**RE: 813-913 WALLGROVE ROAD, HORSLEY PARK –  
FLOOD IMPACT ASSESSMENT ADDENDUM 2**

**Gazcorp Industrial Estate Modification 1  
(SSD-5248 MOD-1)  
Request for Additional Information**

4. The Department notes a Flood Impact Assessment (FIA) Addendum was submitted with the modification application which refers back to a previous FIA for the approved development. The Department requires further clarification from your technical consultant regarding the potential on and off site impacts of the modified development.

**Figure 3 Gazcorp Industrial Estate Stormwater Concept Plan (Approved Design)**  
Reference: X12254.W DWG 04 STORMWATER CONCEPT PLAN 02/08/2013

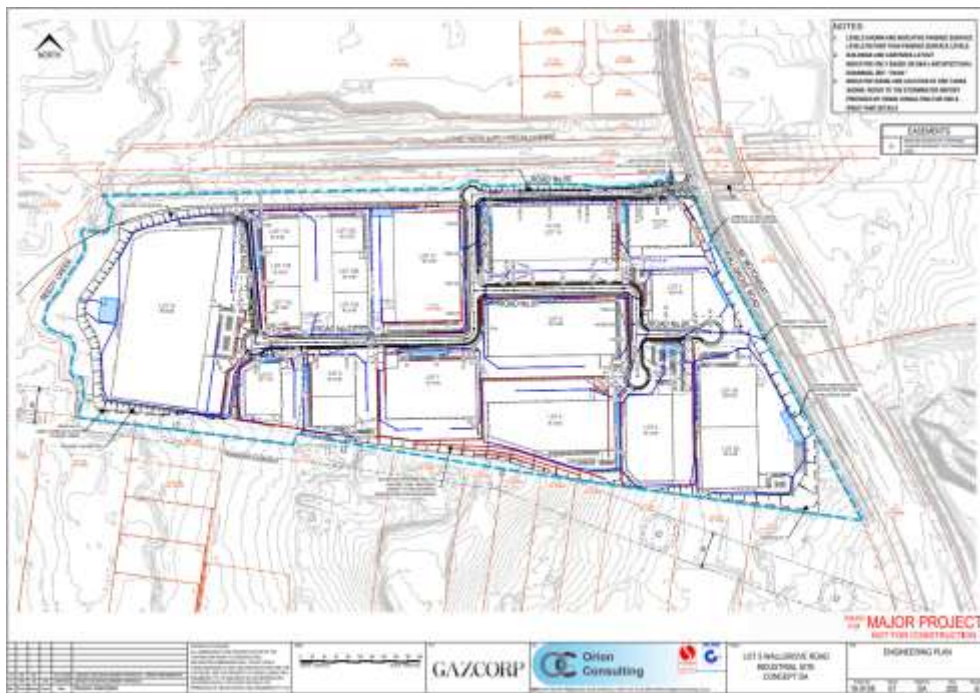
In regard to impacts on the local catchment to the east of the site, the approved and modified design stormwater management plans are shown in Figure 3 and Figure 4, respectively.

As per Calibre Consulting (2015), the approved design included a 20 m wide swale to capture flow from the external catchment to the south-east (upstream) and divert it to the culverts underneath Wallgrove Road. This swale was incorporated in the hydraulic modelling of post-development flood conditions documented in the BMT (2015) flood impact assessment. As shown in Figure 5 and Figure 6, the

Figure 5 Swale Extract from Gazcorp Industrial Estate Stormwater Concept Plan (Approved Design)

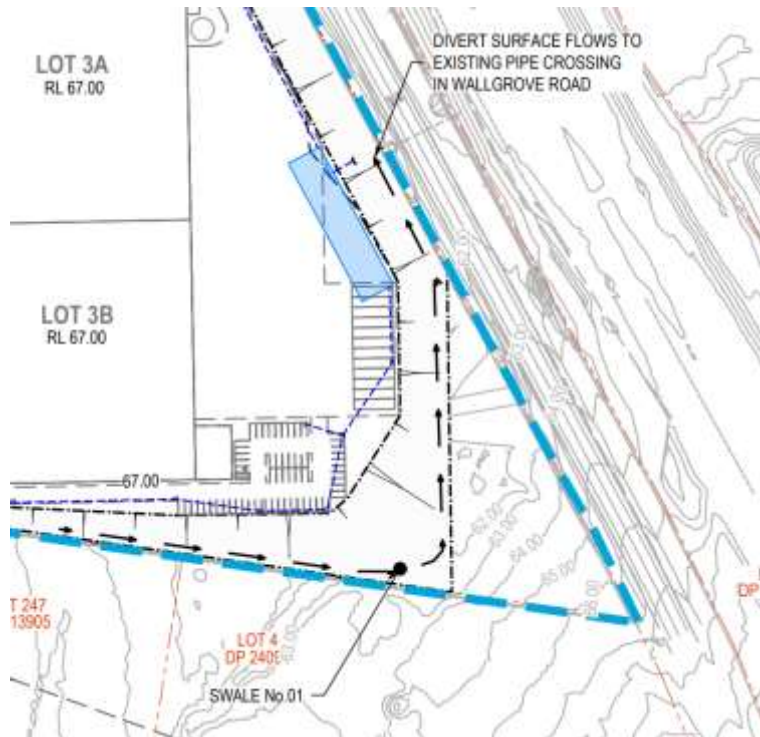
Orion Consulting has advised BMT that the final design of the proposed swale is to be consistent with the parameters outlined for Swale 1 in Calibre Consulting (2015) (included in Table 1 below). If this is the case, then providing that and other works on-site are in line with the modified design, then it is considered that:

It is recommended that the swale is verified against the approved parameters at the detailed design stage.

**Figure 1 Gazcorp Industrial Estate – Approved Design (November 2019)**

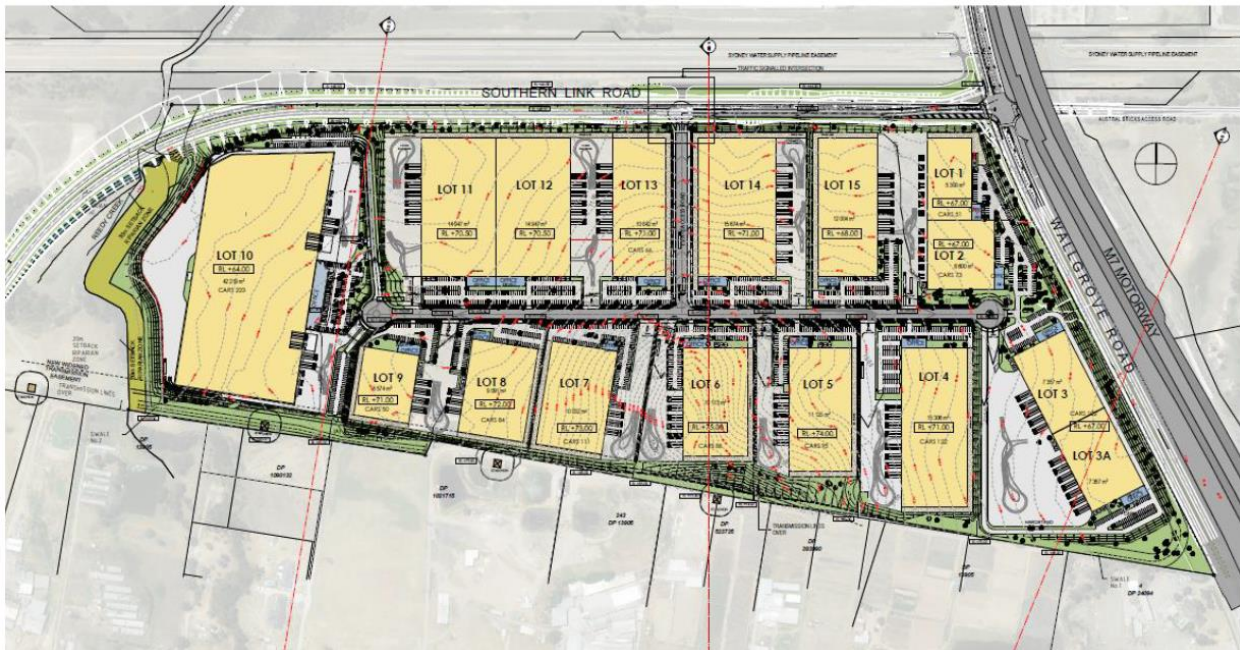
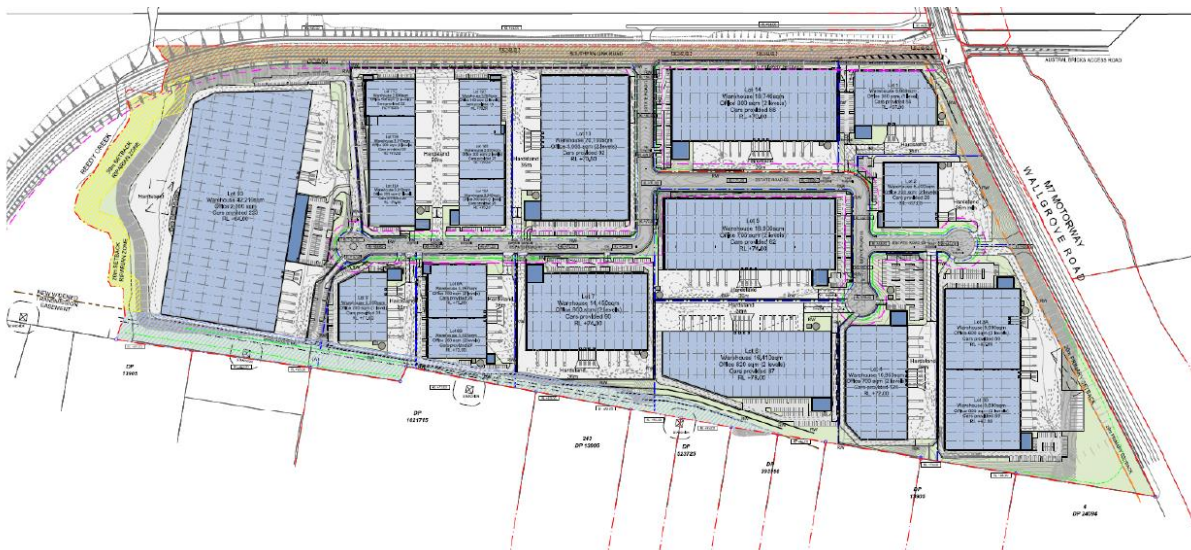
DPIE's response (via the Environment, Energy and Science Group) to the modified design includes the following flood related comments:

As outlined above, the modified design does not propose any changes to the approved design at Lot 10. Accordingly, there would be no change in how the western and north-western sides of Lot 10 encroach into the floodplain of Reedy Creek in the modified design when compared to the approved design. The previous FIA assessed the approved design using the flood models developed for the *Rural Area Flood Study – Ropes, Reedy & Eastern Creeks* (BMT WBM, 2013) to evaluate potential flood impacts. It is therefore considered that:

Title:  
**813-913 Wallsgrove Rd, Horsley Park**  
**100 Year ARI Change in Peak Flood Height**

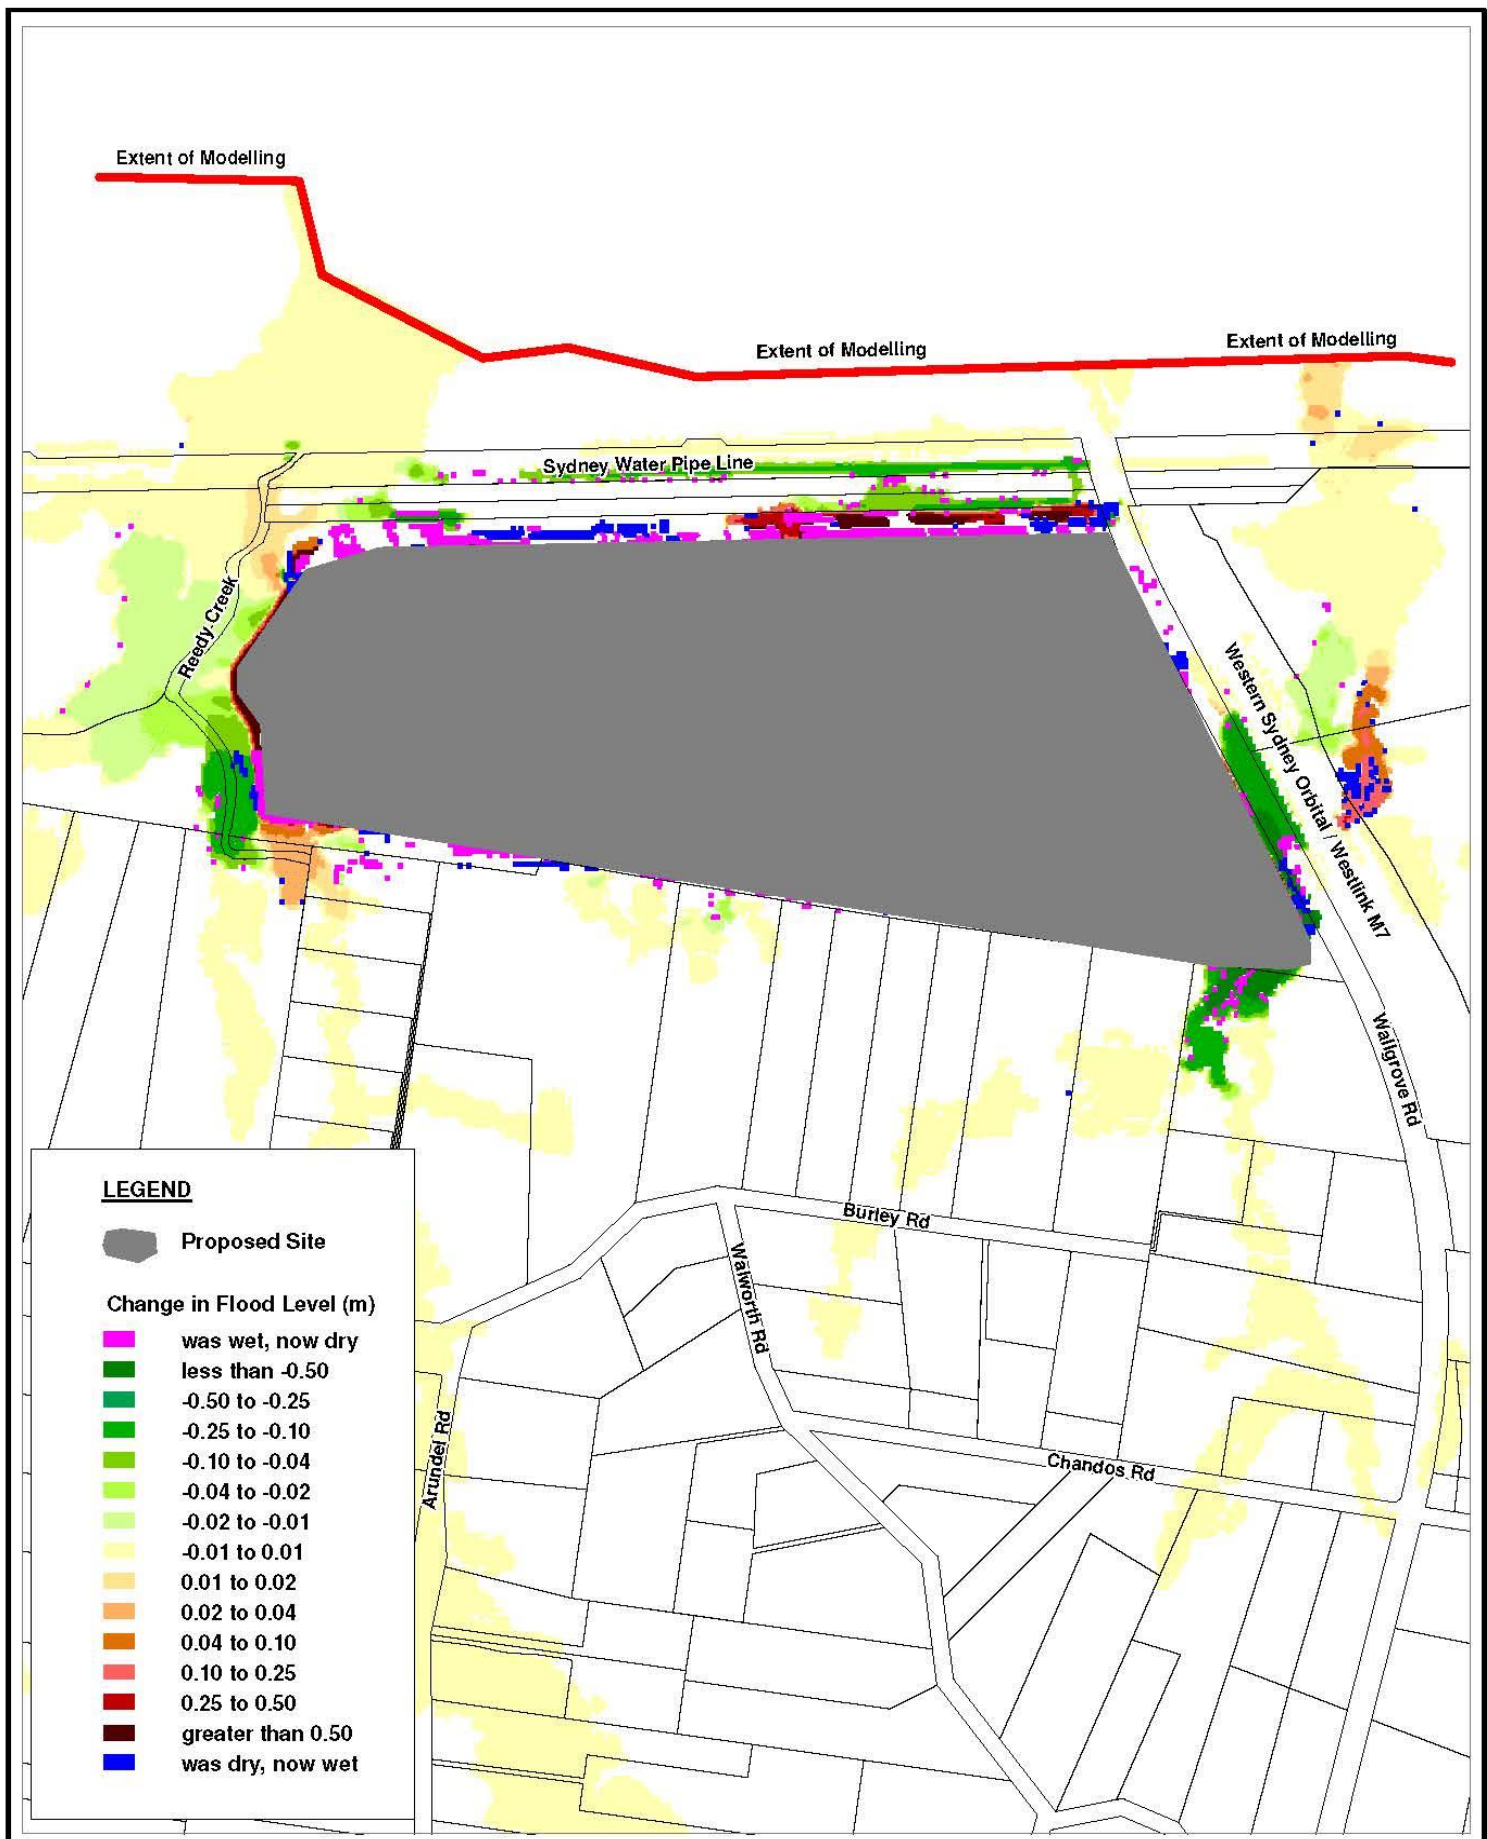
Assessments of flood level impacts along the western boundary at Reedy Creek, and of flood velocity impacts at the same location are provided in Section 6.2 and 6.3 of the previous FIA respectively and address the flood-related comments supplied in DPIE’s response.

Peak flood level and velocity impacts for the 100 year ARI event for the approved design have been extracted from the previous FIA and shown as attached. The previous FIA and this addendum focus only on flood impacts external to the site, and stormwater management within the development is covered by the Stormwater Concept Plan prepared by Orion Consulting (dated 13<sup>th</sup> November 2020).
